SHINE Technologies, LLC Application for an Operating License Supplement No. 22 and Revision 1 of the SHINE Response to Request for Additional Information 7-15

**SHINE TECHNOLOGIES, LLC APPLICATION FOR AN OPERATING LICENSE
SUPPLEMENT NO. 22 AND REVISION 1 OF THE SHINE RESPONSE TO REQUEST FOR
ADDITIONAL INFORMATION 7-15**

**TECHNICAL REPORT NUMBER TECRPT-2018-0028, REVISION 2
HIPS PLATFORM APPLICATION SPECIFIC ACTION ITEM REPORT FOR
THE TRPS AND ESFAS**

REVISION 1 OF THE SHINE RESPONSE TO REQUEST FOR ADDITIONAL INFORMATION 7-15

Figure 7-15-1: TRPS and ESFAS Gateway Communications Architecture

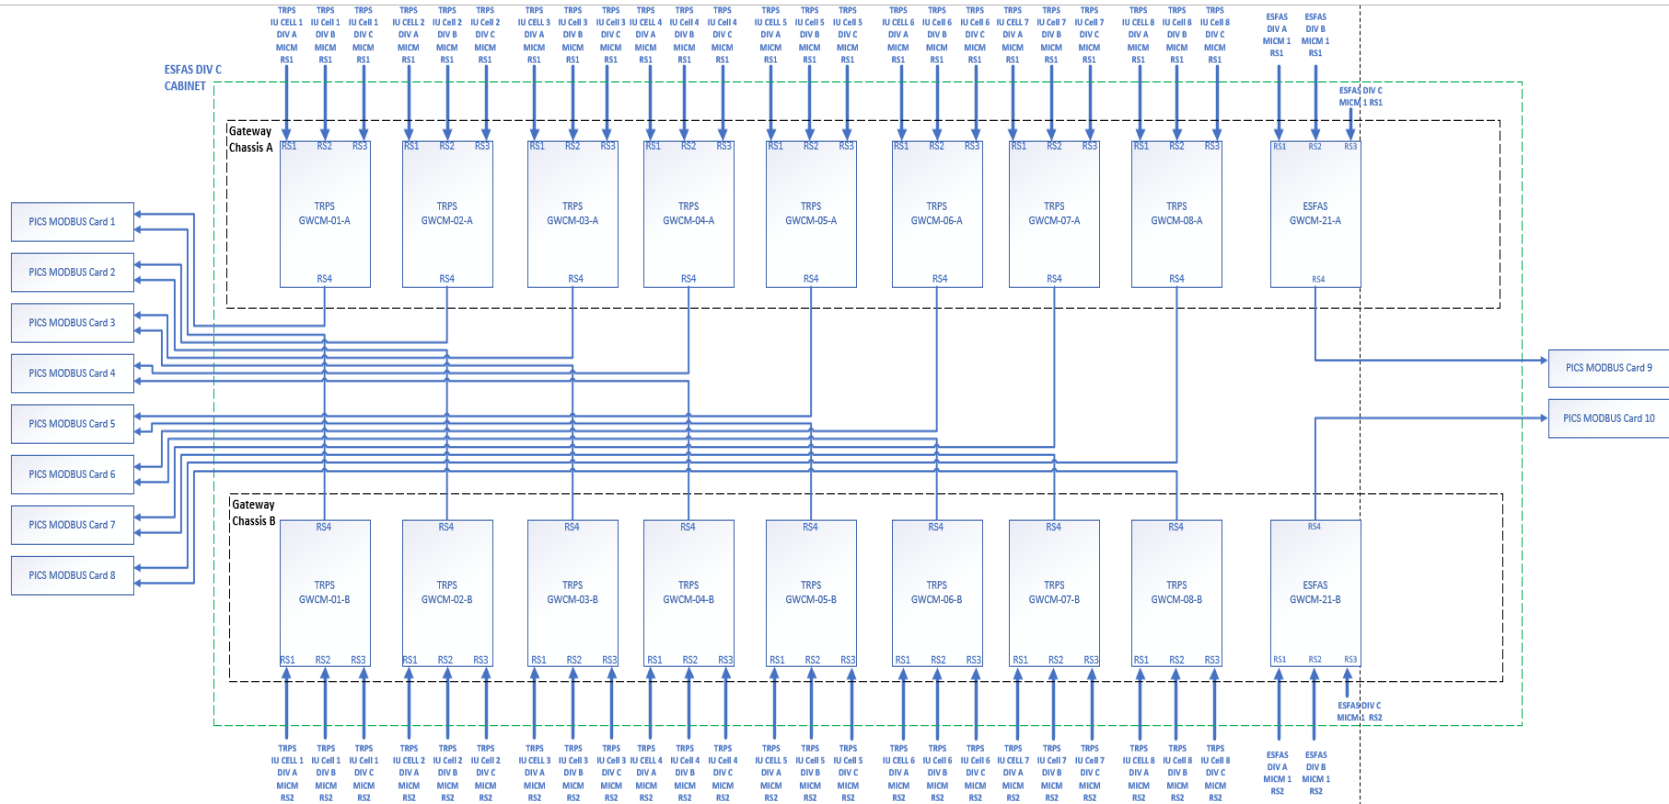
Update the SHINE FSAR to describe how diagnostic and maintenance features are implemented in the HIPS equipment for the TRPS and ESFAS. Demonstrate that the features provide necessary test coverage. Also, demonstrate that the use of these features won't prevent the systems from performing their safety and protection functions.

- Modification of configurable variables and setpoints
- Features and limitations to perform in-chassis calibration
- Surveillance tests using automatic sensor cross-check
- Test and calibration functions of the HIPS platform and compliance with regulatory guidance
- Validation of self-testing functions in HIPS equipment

The TRPS and ESFAS have redundant gateways which gather the output of the monitoring and indication communications modules (MICMs) for each of the three divisions, as depicted in Figure 7-15-1 Revision 1. The data for each of the three divisions are compared to perform a channel check, and the results are provided to the process integrated control system (PICS).
